**COMMISSION FOR
HISTORICAL & ARCHITECTURAL
PRESERVATION**

STAFF REPORT

REQUEST: Concept Review-Height, Massing and Scale of new additions and Rehabilitation of existing historic structure and facades

ADDRESS: 719-723 West Pratt Street (Ridgely's Delight Historic District)

Massing model from northeast

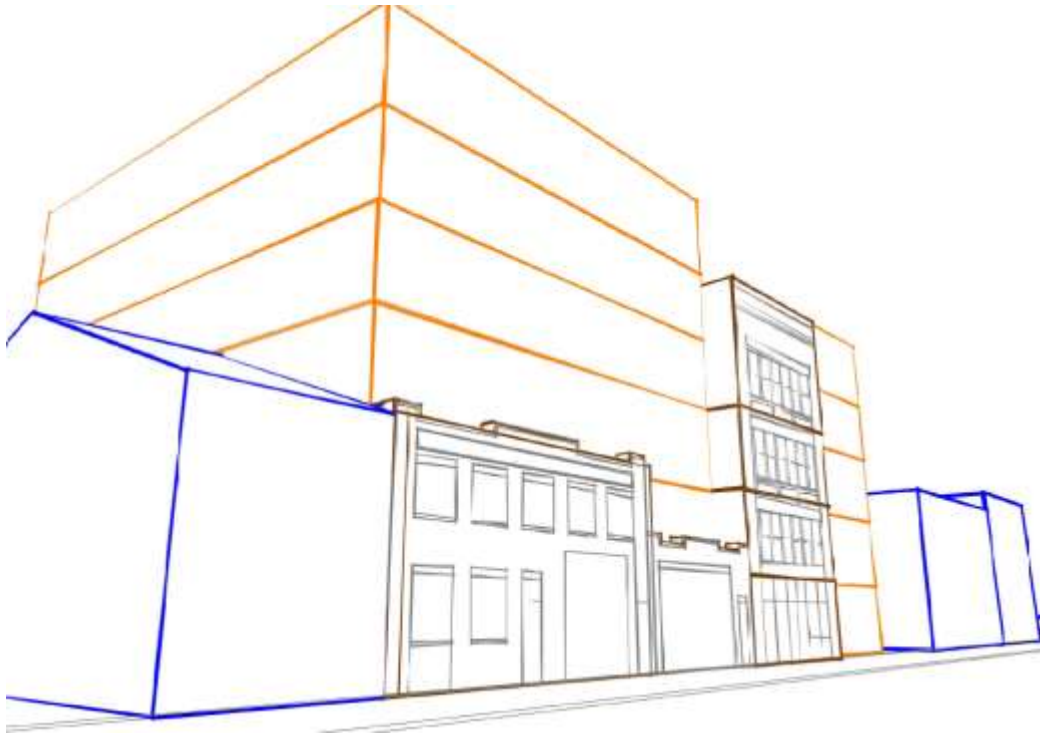
ANALYSIS: CHAP Staff has determined that the proposed east and west additions meet the CHAP guidelines for height, massing and scale. Both additions address and comply with the guidelines and staff recommends that the concept plans be approved by the commission. Staff notes that numerous elements exist on the façade and the applicants should examine simplifying the elements as they have done so on the rear elevation. Staff also believes in moving the top floor level into the same plane as the majority of the façade on the east addition.

4. Staff recommends that the applicant explore simplifying the façade cornice level of the east addition
5. Staff recommends extending the façade plane to meet the top floor level.
6. Staff recommends that Final Design Plans return to the full Commission.
